RS-15-221

Subject: Revisions to LaSalle County Station, Units 1 and 2, License Renewal Application, Applicant's Environmental Report – Operating License Renewal Stage

Enclosure: LaSalle County Station Units 1 and 2, Revisions to License Renewal Application, Applicant's Environmental Report – Operating License Renewal Stage

Figure 2.2-1 LSCS Site Layout

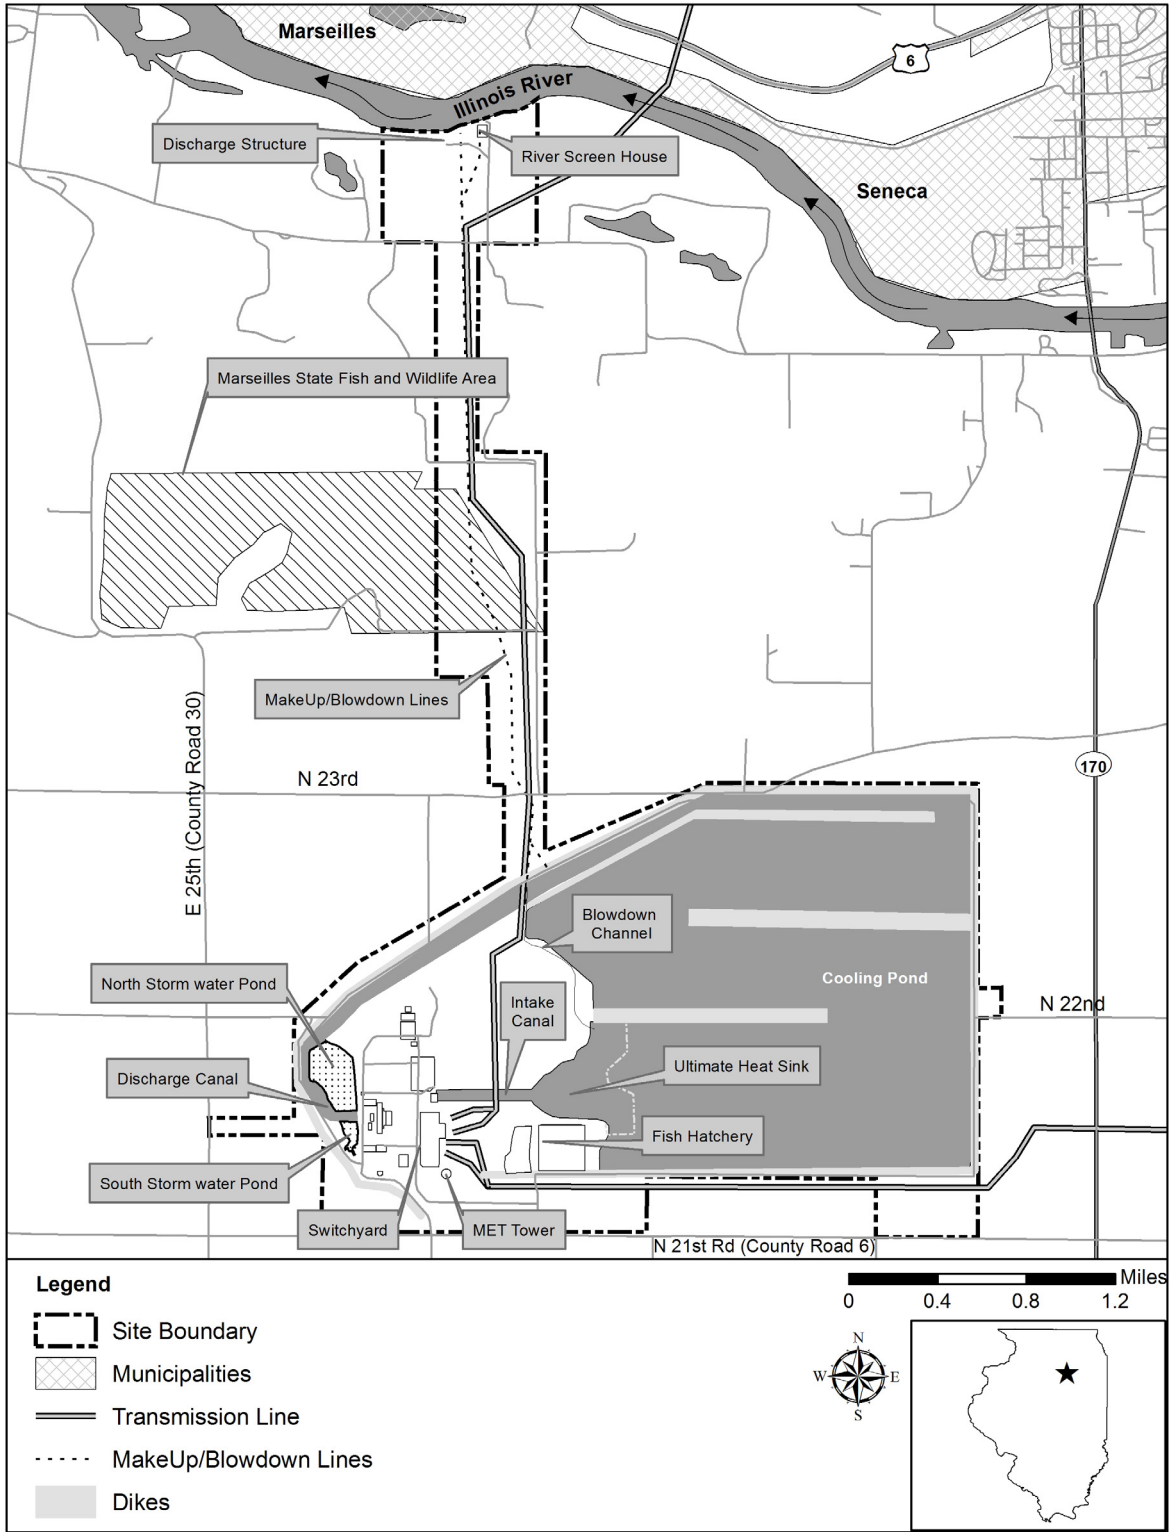
ER-LR Page #	ER-LR Section #	Description of Revision	Purpose of Revision
Cover page	Not applicable	Added ER-LR revision number and changed document date to July 2015	To provide updated document information.
2-5	2.2	Revised Figure 2.2-1, LSCS Site Layout	To correct the location of LSCS property ownership boundaries.
2-6	2.2	Revised Figure 2.2-2, LSCS Plant Layout	To correct the location of LSCS property ownership boundaries.
3-2	3.1	In 2 nd paragraph, 1 st line on the page, changed LSCS total land area from 1,568 ha (3,875 ac) to 1,528 ha (3,776 ac)	To revise the total land area value within the corrected LSCS property ownership boundaries.
3-4	3.2	Revised Figure 3.1-2, 6 Mile (10 km) Radius Map	To correct the location of LSCS property ownership boundaries.
3-5	3.2	In 1 st paragraph, 10 th line on page, updated the reference citation for the National Land Cover Database (NLCD), to the 2011 version of the NLCD (i.e., NLCD 2012)	To clarify that land areas occupied by land use types within the corrected LSCS property ownership boundaries, as presented in Table 3.2-1, have been updated using the 2011 version of the NLCD.

Figure 3.2-1 Land Use 6-Mile Map

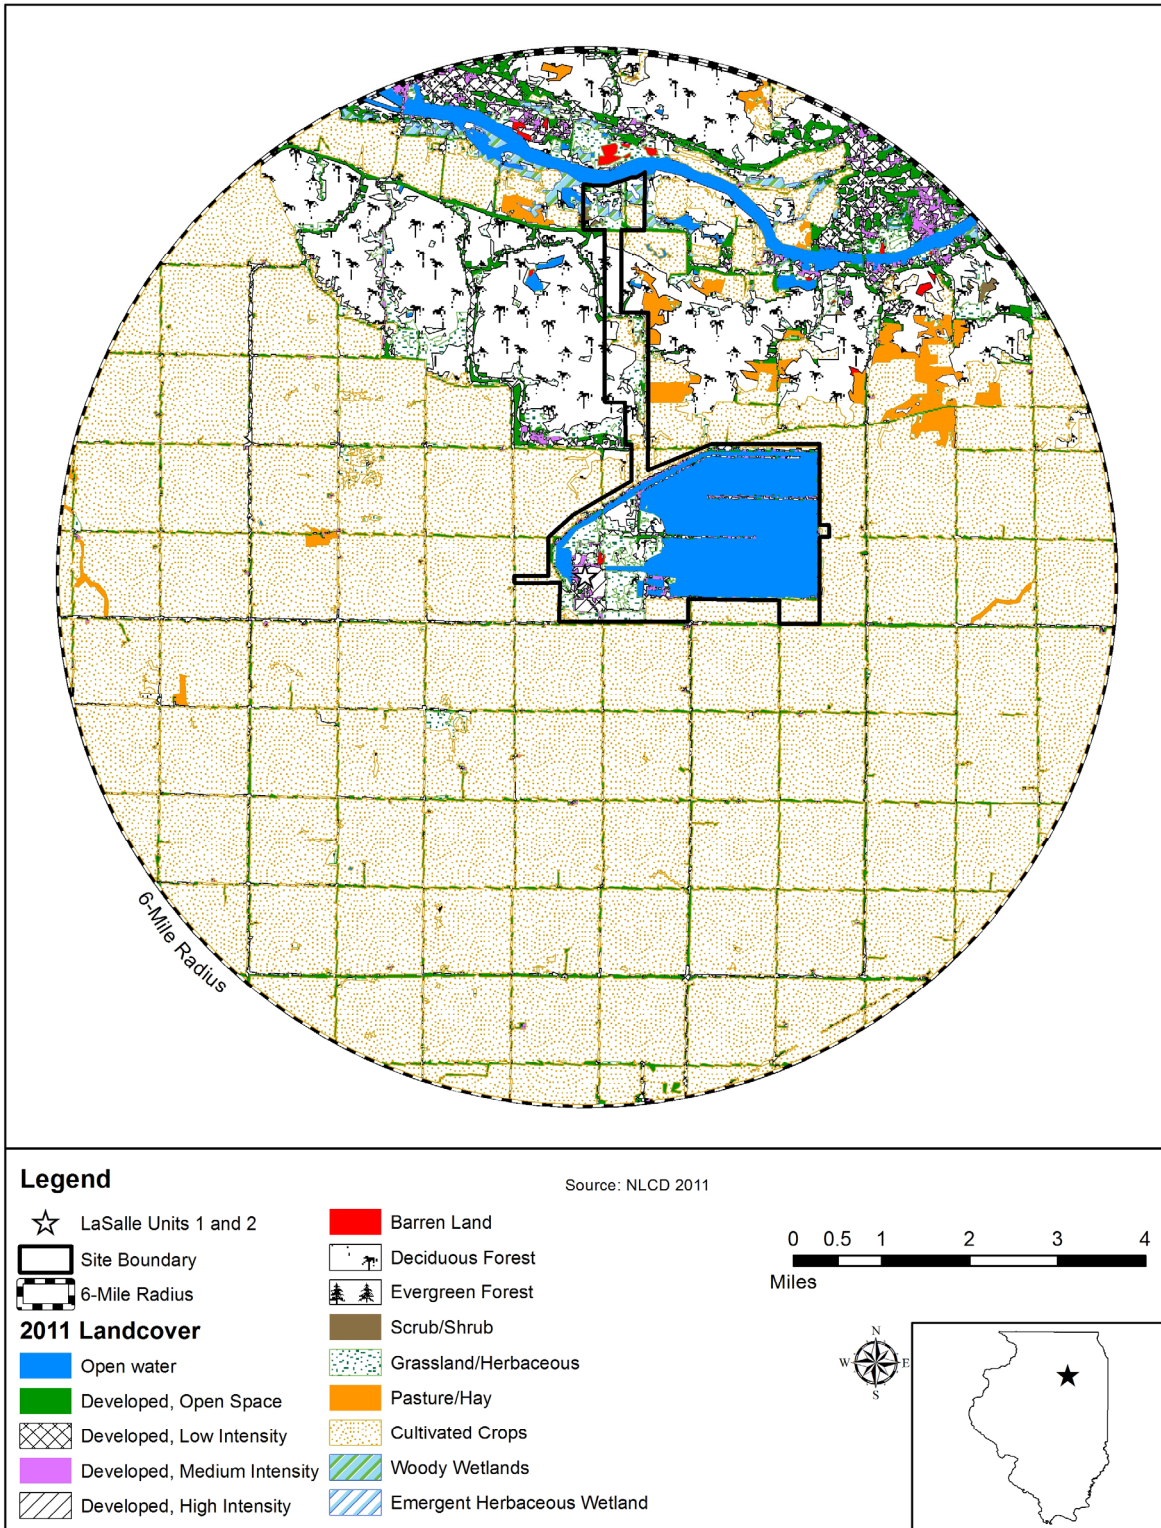
ER-LR Page #	ER-LR Section #	Description of Revision	Purpose of Revision
		LSCS land area occupied by undeveloped acreage from 101 ha (250 ac) to 142 ha (350 ac)	
3-7	3.2	Revised Figure 3.2-1, Land Use 6-Mile Map	To correct the location of LSCS property ownership boundaries and update areas depicted for land cover types to be consistent with the 2011 NLCD.
3-8	3.2	Revised Figure 3.2-2, Land Use - Site	To correct the location of LSCS property ownership boundaries and update areas depicted for land use types to be consistent with the 2011 NLCD.
3-11	3.2	Revised Table 3.2-1, Land Use in the 10-km (6-mi) Radius of LSCS	To revise the values for land areas occupied by specific land cover types within the corrected LSCS property ownership boundaries.
3-18	3.4	Revised Section 3.4, Noise	To more accurately describe applicable state noise control standards as well as current ambient noise sources in the vicinity of LSCS.

Figure 3.5-2 Agricultural Soil Characterization Map

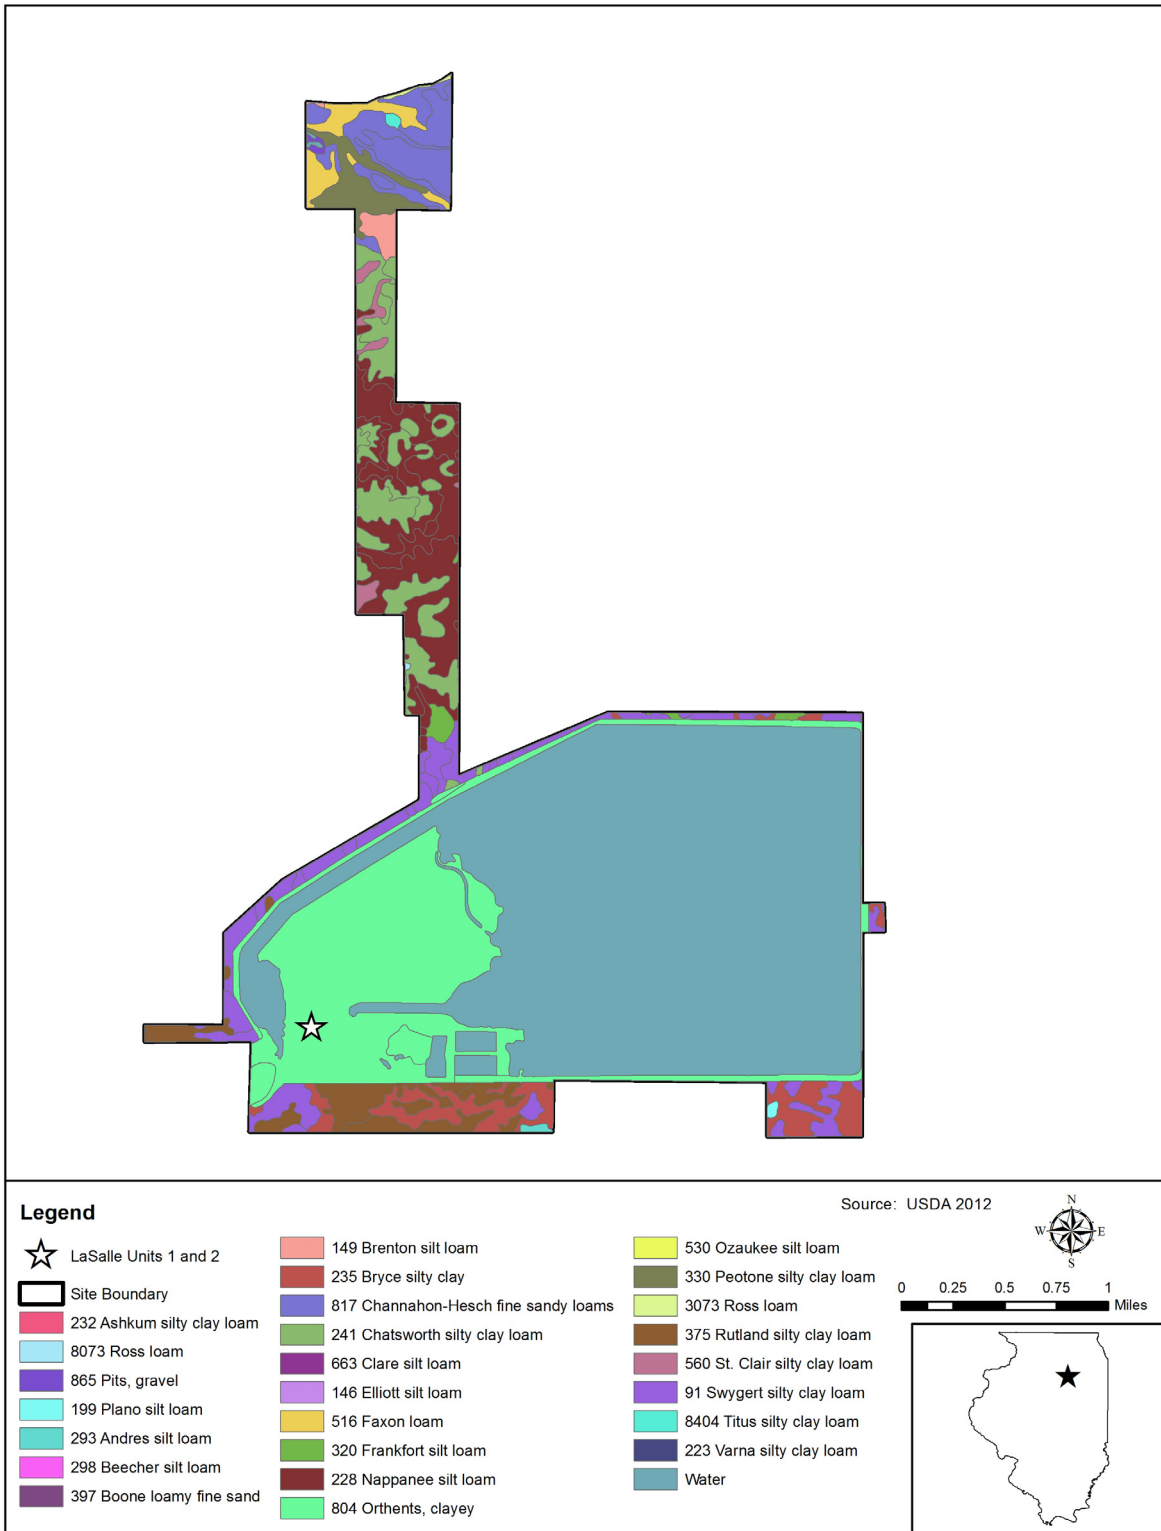
3-24	3.5	Revised Figure 3.5-2, Agricultural Soil Characterization Map	To correct the location of LSCS property ownership boundaries.
3-32	3.6	Revised Figure 3.6-1, Surface Water and Groundwater Well Locations at LSCS	To correct the location of LSCS property ownership boundaries.
3-35	3.6	Revised Figure 3.6-2, Groundwater Flow Map	To correct the location of property LSCS ownership boundaries.
3-48	3.6	Revised Table 3.6-3, Wells within a 1-mi (1.6-km) Radius of LSCS, by changing the entry in the "Well Depth" column for row "8" in the "Well Id" column from "235 (7700)" to "235 (770) "	To correct a typographical error.
3-50	3.7	In 1 st paragraph, 1 st line on page, changed LSCS total land area from 1,568 ha (3,875 ac) to 1,528 ha (3,776 ac)	To revise the total land area values within the corrected LSCS property ownership boundaries.
3-61	3.7.1.7	Revised Section 3.7.1.7, Special Status Aquatic Species	To acknowledge the changed regulatory status of the American eel, which was listed as threatened in May 2015 by the Illinois Department of Natural
